Design Review of the Salt River Channelization Project

Phoenix, Arizona

30 October 1980

U.S. Army Corps of Engineers, Sacramento
John A. Sibilsky, Project Manager

Fig. VII-12 Location of Model Levee Erosion

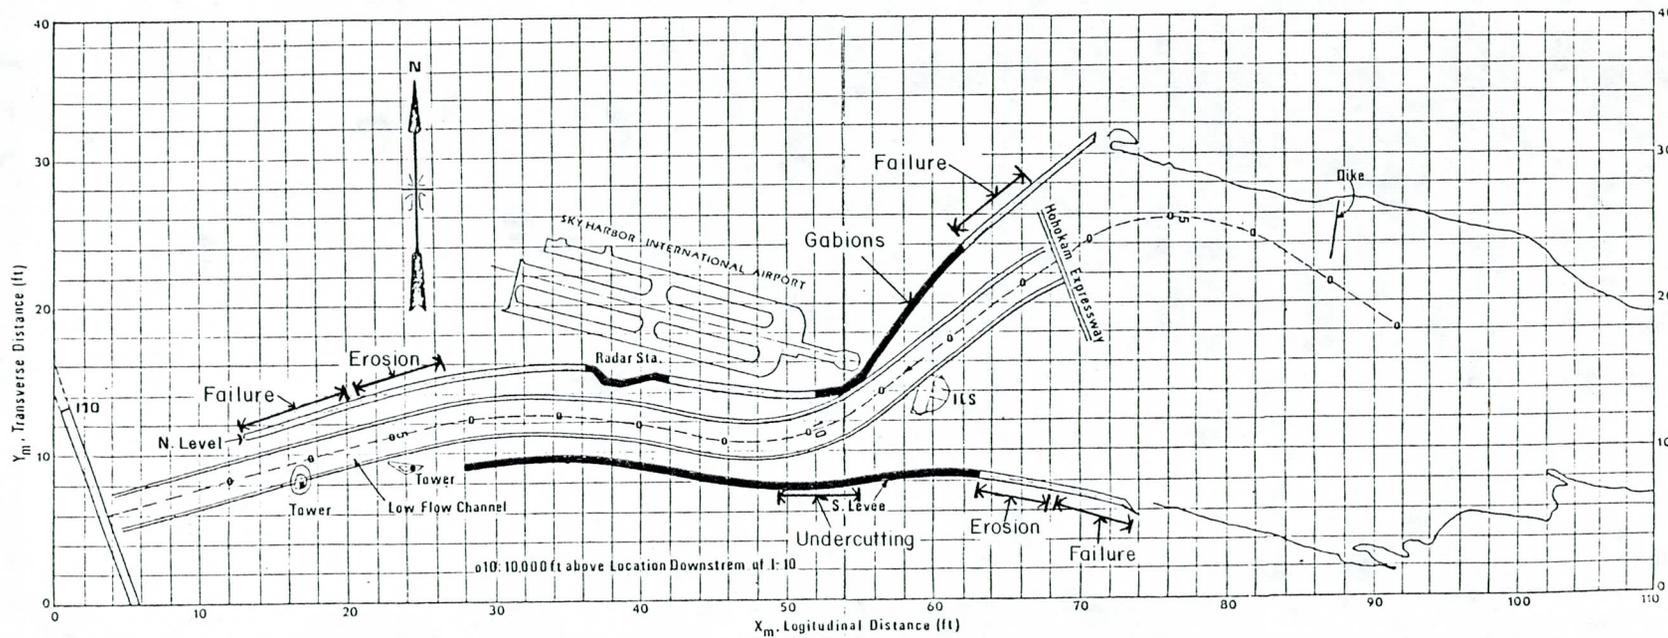
The levee protection proposed by the City of Phoenix and the areas of model levee damage are shown in Figure VII-12. Figures VII-13 and VII-14 show photographs of the unstable levee sections. Unprotected levee sections 1) upstream of the ILS on the north side, 2) upstream of the ILS on the south side, and 3) downstream of the radar station on the north side experienced extreme scour in both the 92,000 cfs and 210,000 cfs runs. Sections of each of these areas were armored during the hydrograph to prevent complete failure. Armored levee sections experienced little or no damage, with the exception of the south levee section downstream of the ILS, which was seriously undercut and slumped, as shown in Figure VII-13 (d). Quantitative damage estimates of these and other impacts are presented in Section X.

Proper armoring of the levee sections identified in Figure VII-12 seems to be necessary to maintain the integrity of the channel. The following additional sections require protection.

FIGURE IX-8. Minimum Bottom Elevations: Mathematical and Physical Model Results

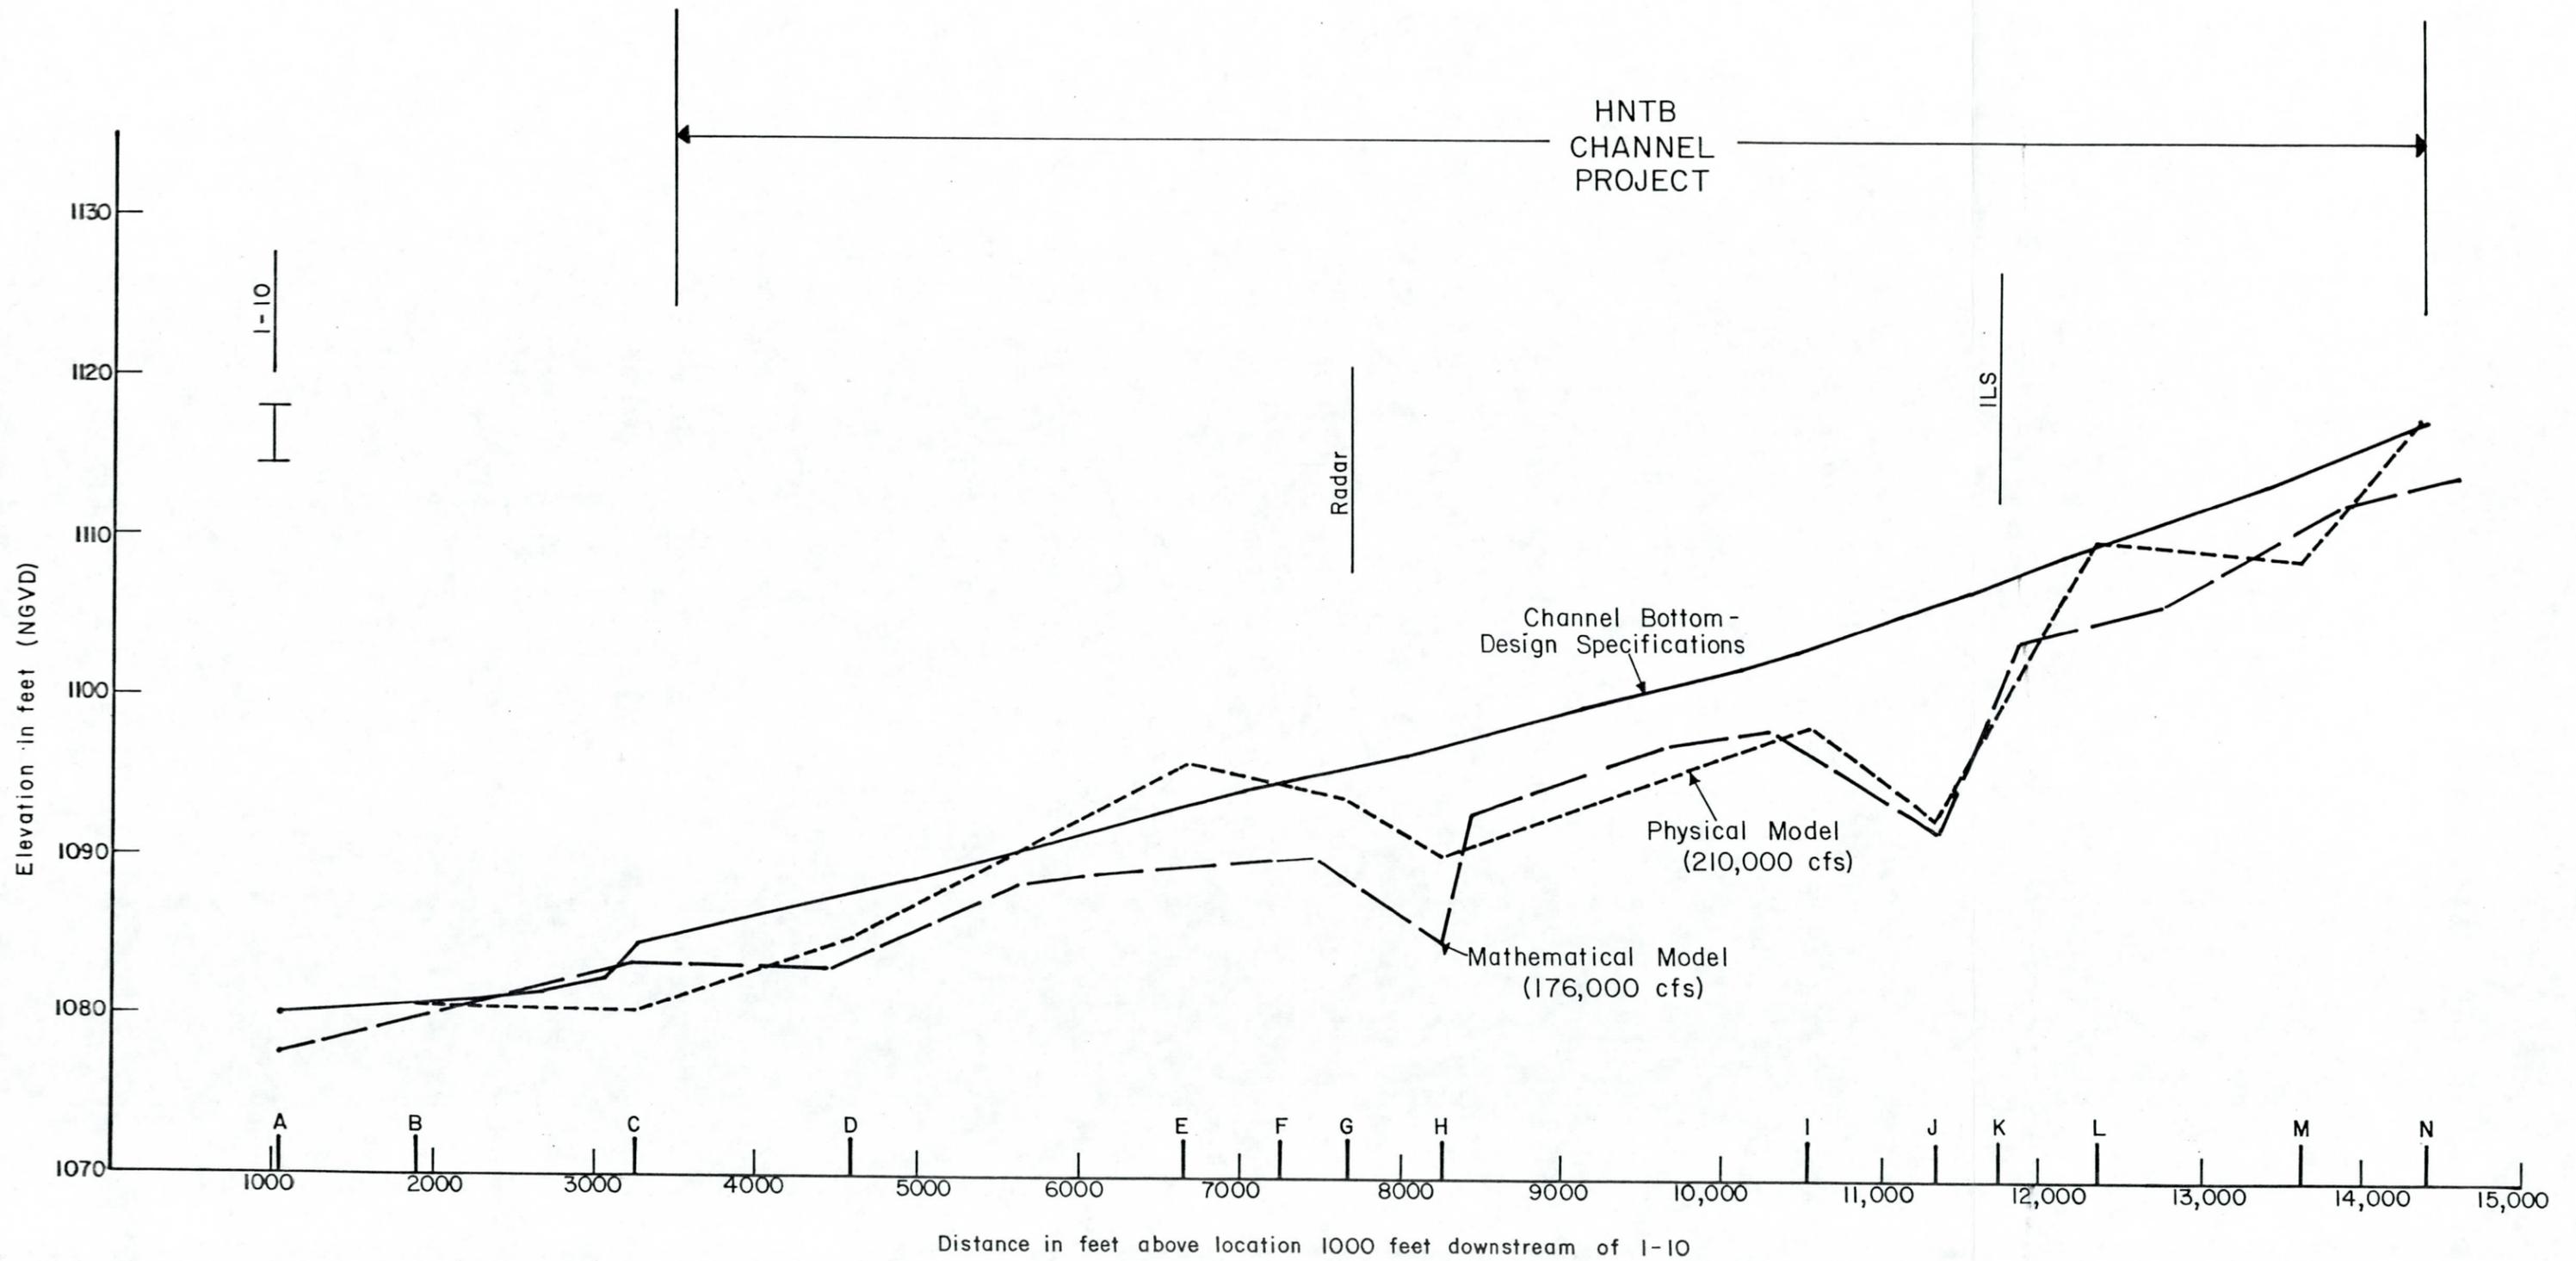
Significant scour of the channel bottom occurs during both the 10-year and 100-year events, as shown in Section VII. Figure IX-8 shows the predicted shift in thalweg elevations, while Figures IX-9 through IX-16 show the formation of scour holes near levee bases at selected cross-sections. Table IX-2 itemizes the areas of serious levee undercutting due to channel degradation.

Figure X-1. Estimated Damages to Channel Levees-10 Year Flood

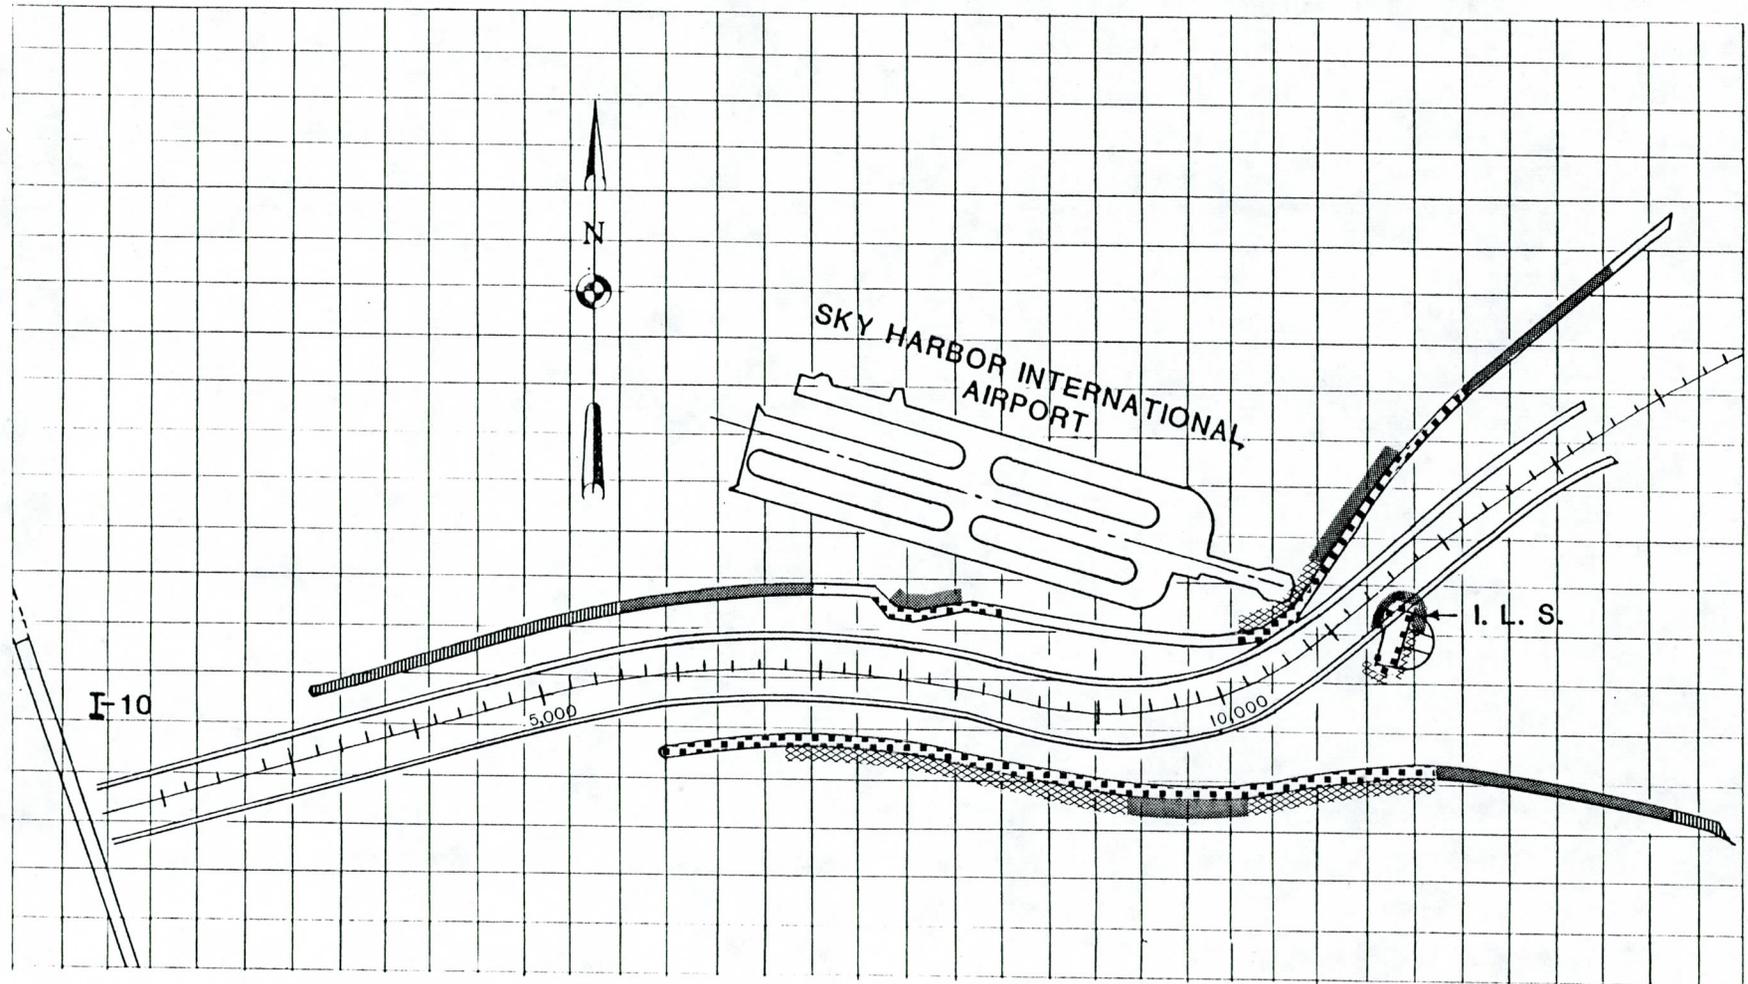
Surrounding Private Properties Breaching of the unprotected upstream levee on the south side of the channel's entrance transition is expected under both the 10 and 100 year floods. (Refer to Figures X-1 and X-2). The private property expected to be flooded on the south side of the channel is shown in Figure X-3 and is more or less bounded by 40th Street on the west and an unnamed access road to the south. This area is undeveloped and no damage to permanent structures is anticipated from either the 10 or 100 year flood.

Figure X-3 Areas of Inundation Due to Potential
Levee Failure- 100 Year Flood

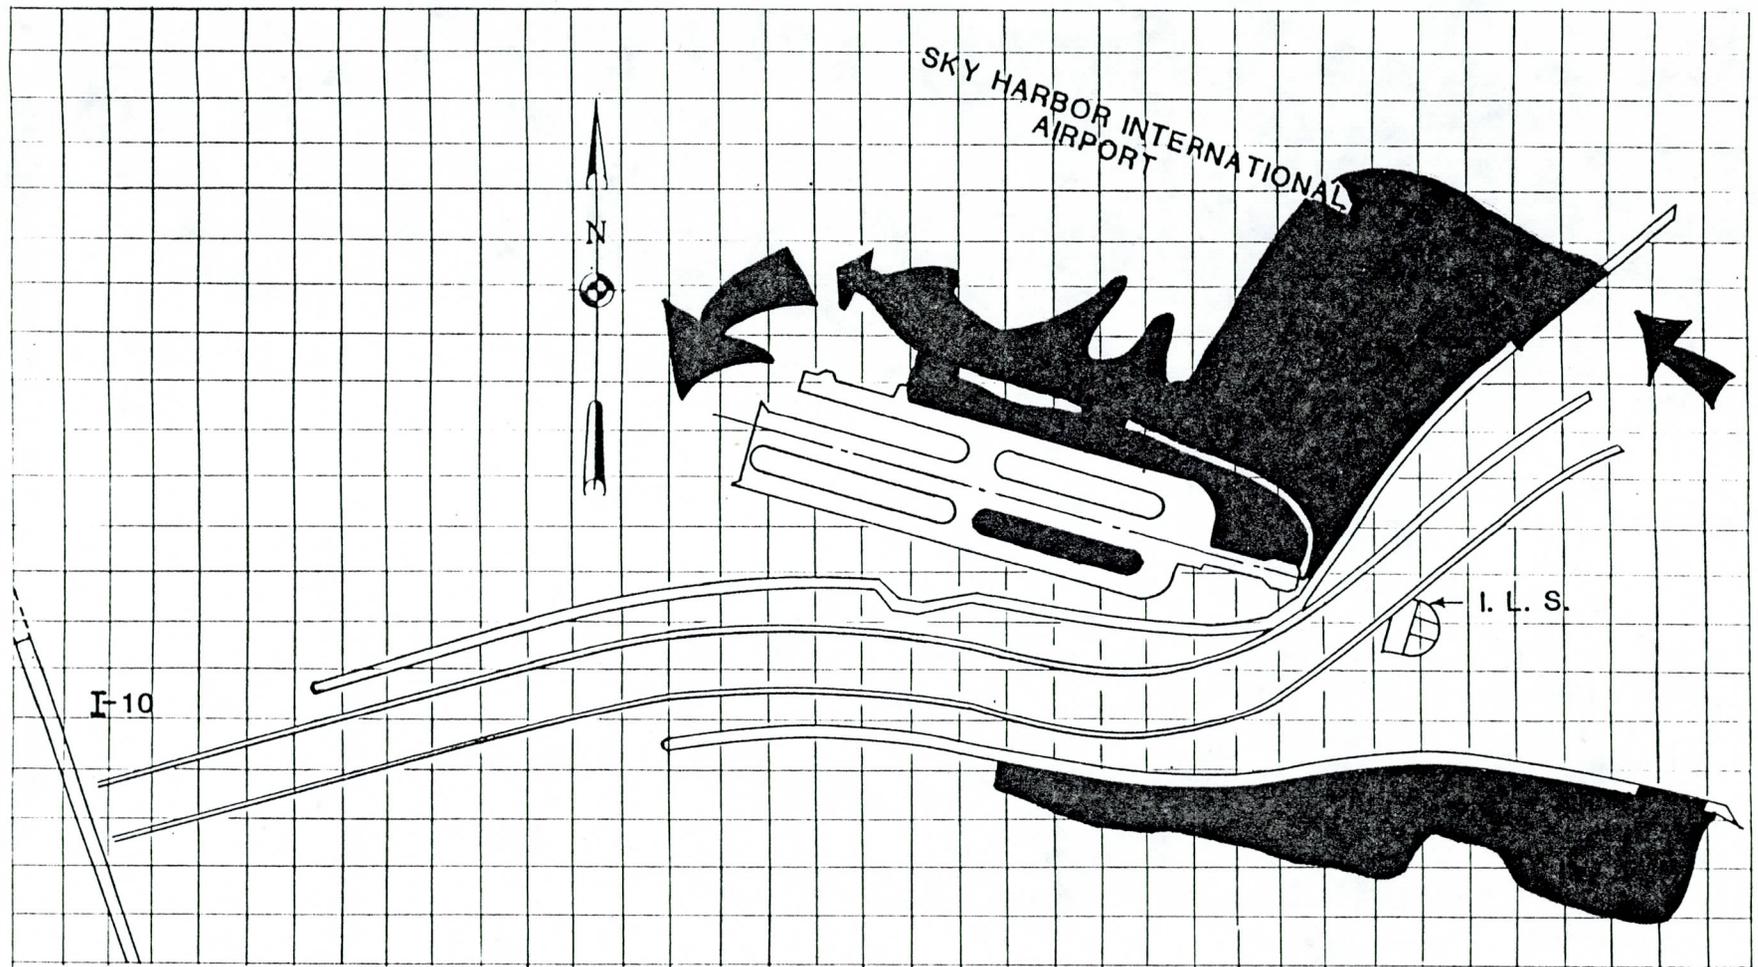
Sky Harbor Airport No damage is expected to occur to the airport from Salt River flooding during the 10-year event. During the 100-year flood, however, it is anticipated that the unprotected north levee upstream of the airport will breach and flood waters will inundate major portions of the airport property. If the breach occurs, the anticipated areas of flooding and the direction of flow are presented in Figure X-3.

The inlet to the double barrelled 72 inch storm drain between Taxiway C and the perimeter road would be submerged by up to 10 feet of water. Water would backflow through the connected inlet in the infield between Taxiway D, cross Taxiway D-7 and the runway, flooding that open area. Certain of the flow would pass through the 2 - 72 inch pipes to the river downstream where the water surface is lower, but would provide little relief to the temporary flooding problem.

Water would continue to pond and rise in elevation until an elevation of approximately 1122 was reached at which point it would flow northwesterly toward the hangar/maintenance/terminal area. There is insufficient data to determine the specific damages that would occur in this area, but the flood waters can be expected to sheet flow through the area, causing significant disruption and damage, until it could reenter the river downstream.

Figure XII-1. Location of Proposed Design Modifications

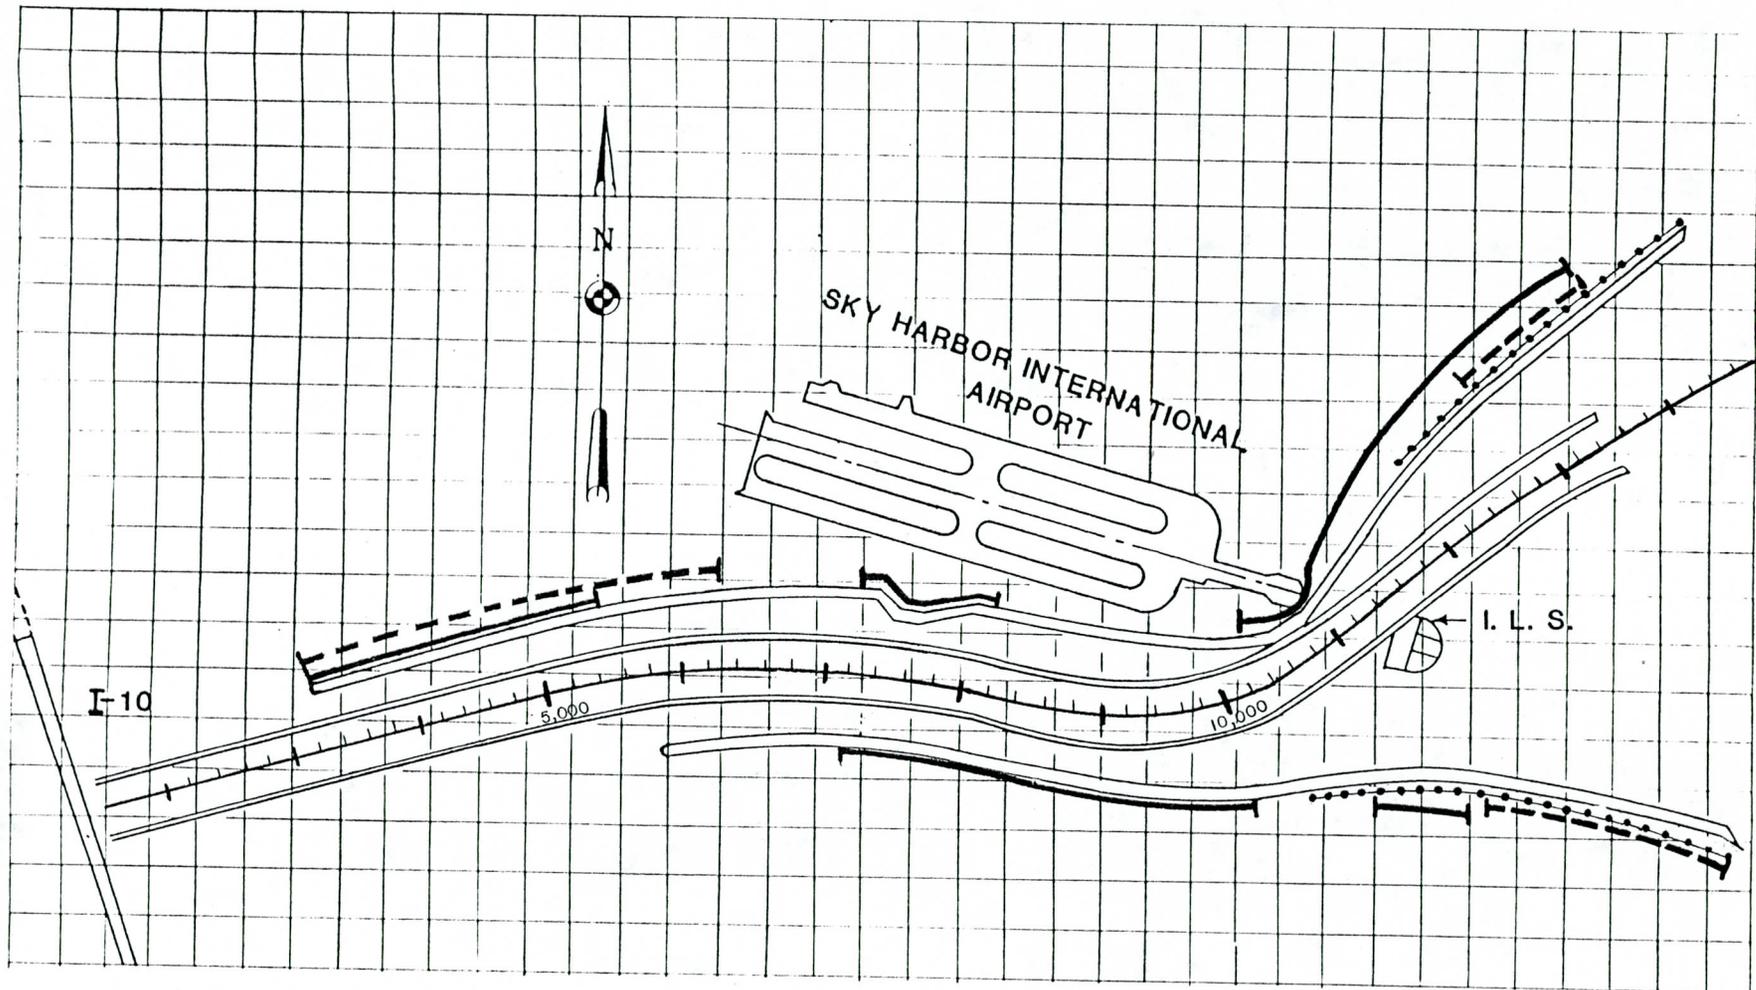
Model and geotechnical studies revealed the need for a number of design changes to meet the requirements of FEMA regulations, as follows:

1. increase levee freeboard;
2. extend levee areas protected by gabions;
3. protect gabions against damage from rock impacts;
4. bury gabions in areas of significant scour
5. provide means to reduce piping through levee foundations;
6. construct channel bottom to shape of ultimate channel equilibrium condition.

From these considerations, freeboards should be no less than 3 feet in the proposed channel. The levee freeboards predicted by the fixed-bed model, as shown in Table VI-4, are well above 3 feet except for upstream of station 10,700. Table IX-1 shows the changes in stage due to sediment transport in the movable bed model. When the freeboards in Table VI-4 are adjusted for the movable-bed model results, the following sections of levees required added height to meet the 3 foot requirement.
